Date: May 5, 2014  
To: All Prime Bidders  
RE: Eugene School District 4j  
Spencer Butte Middle School – Energy Efficiency Upgrades  
C.I.P. No. 420.578.032

**ADDENDUM #3:**

Re: Spencer Butte Middle School – Energy Efficiency Upgrade  
C.I.P. 420.578.032

Following are changes to the Structural Drawings:

PARTIAL  
PLAN 1/52.1

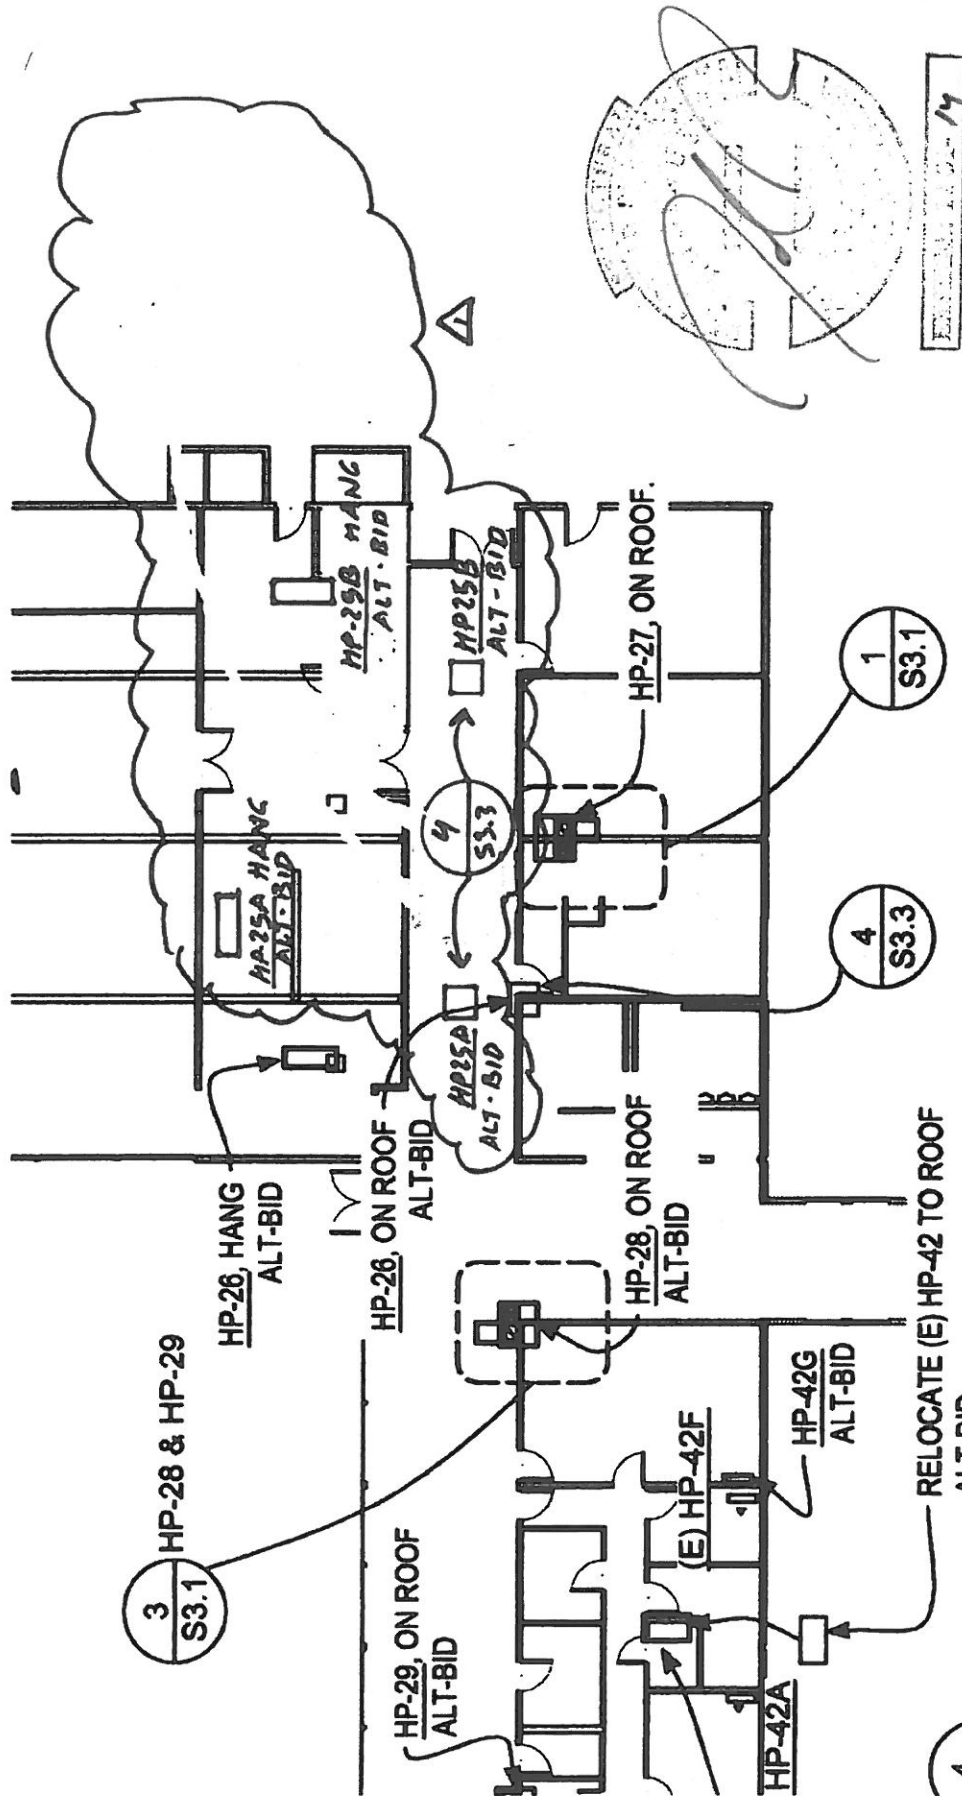
2. 1/S2.1 HVAC UPGRADES FLOOR PLAN: In northeast area south of cafeteria; **Delete** HP-25 and Detail call-out 1/S3.3. **Delete** openings through south cafeteria wall and Detail call-out 3/S3.3. **Add** HP-25A and HP-25B units (outdoor sections) on roof and Detail reference 4/S3.3. **Add** HP-25A and HP-25B units (indoor sections) hung from roof and reference to Note 6. **See attached partial plan.**

DETAIL 9/53.1

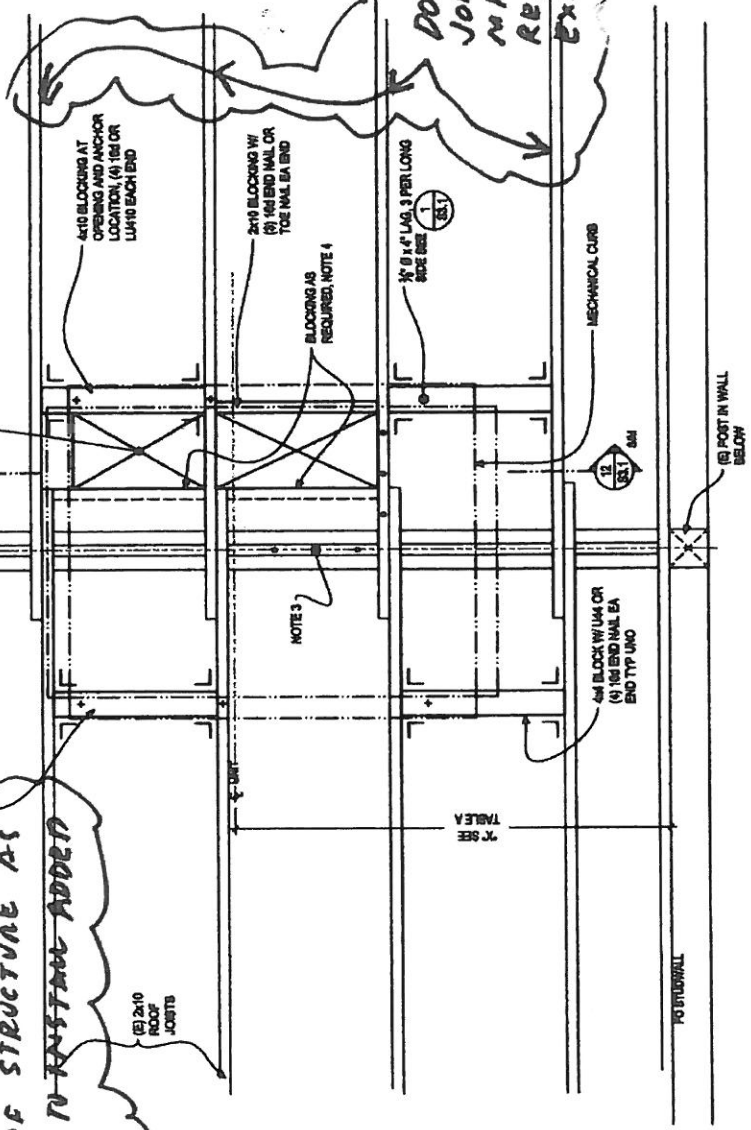
**Revise** Detail 9 per attached to show similar condition associated with HP-37.

5'-0' MAX  
 UNIT AT SIM. (HP-37)

DOUBLE EXISTING JOIST AT SIM, REMOVE AND REPLACE PORTION OF EXISTING ROOF SHEATHING.

DETAIL 15/S3.1

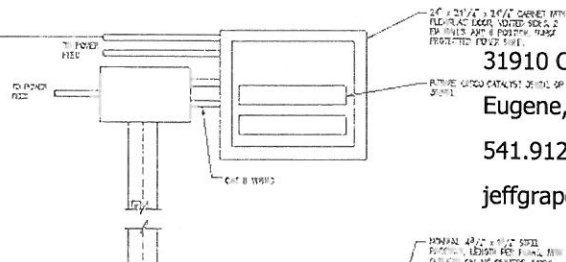
**Revise** Detail 15 per attached to show changed HP-25.
